### Product Change Notification

Affected product:  
**DPM380-415AD, DPM380-415AD**

Device Identification:  
**DPM380-415AD, DPM380-415AD** with starting from serial number 1825217 onwards

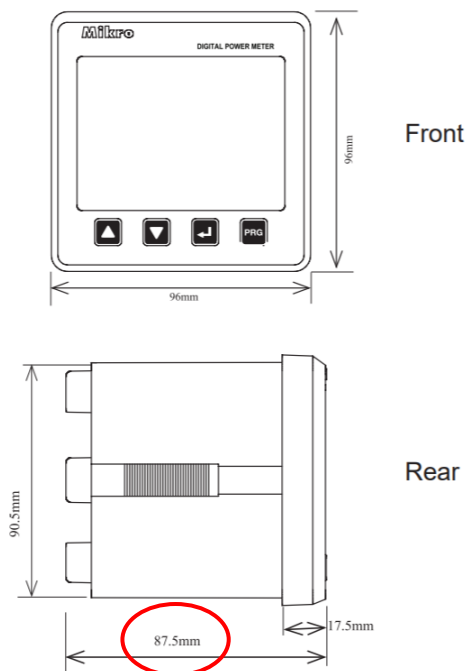
The changes is only physical where the length of the meter is reduced from **105mm to 87.5mm**. **The function, the wiring connection and the weight remains unchanged**. The new dimension of the meter will be 96(w) x 96(h) x 87.5(d). This change allows a the meter to be mounted to an electrical panel with smaller depth.
